APPLICATION NO.	FILING DATE	FIRST NAMED INVENTOR	ATTORNEY DOCKET NO.	CONFIRMATION NO.
10/698,091	10/31/2003	William J. Worrell JR.	20020391.ORI	9704
23595 7590 02/07/2007 NIKOLAI & MERSEREAU, P.A. 900 SECOND AVENUE SOUTH SUITE 820 MINNEAPOLIS, MN 55402			EXAMINER CHAMBERS, TROY	
			ART UNIT	PAPER NUMBER
			3641	
SHORTENED STATUTORY PERIOD OF RESPONSE		MAIL DATE	DELIVERY MODE	
3 MONTHS		02/07/2007	PAPER

Office Action Summary

DETAILED ACTION

Fig. 2

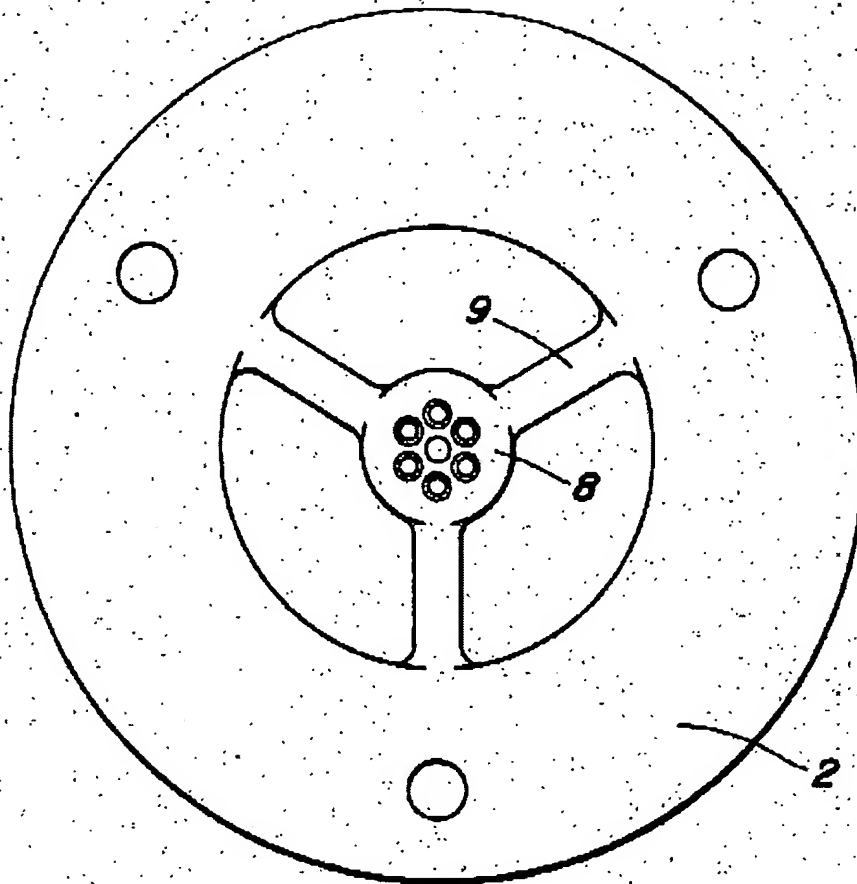
2. Claims 1-7 and 13-15 are rejected under 35 U.S.C. 102(b) as being clearly anticipated by US 3778217 issued to Bustamante et al.

4. Claim 10 is rejected under 35 U.S.C. 103(a) as being unpatentable over Bustamante. Bustamante discloses an extrusion die as shown above. However, Bustamante does not disclose a pin shape that is non-round. At the time of the invention, it would have been obvious to one having ordinary skill in the art to make the pins of Bustamante to be non-round since it has been held that such changes are a matter of design choice. In re Dailey, 357 F.2d 669, 149 USPQ 47 (CCPA 1966) (The court held that the configuration of the claimed disposable plastic nursing container was a matter of choice which a person of ordinary skill in the art would have found obvious absent persuasive evidence that the particular configuration of the claimed container was significant.) Moreover, the applicant's specification did not mention that such a shape is critical to the operation of the invention.
